## CITY OF ALBUQUERQUE

Site: Wecks Restaurant, 7301 Paseo Del Norte NE

Re: Drainage Ordinance (14-5-2-1) Violations for Erosion and Sediment Control

Site being graded.

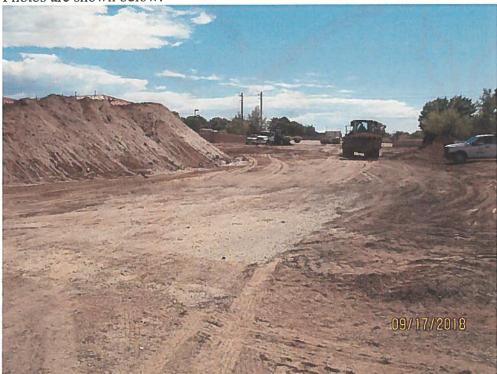
1. This project will disturb one acre or greater. Earth disturbance has begun at the site and stormwater controls have not been implemented.

1. Implement stormwater controls per approved Erosion and Sediment Control Plan.
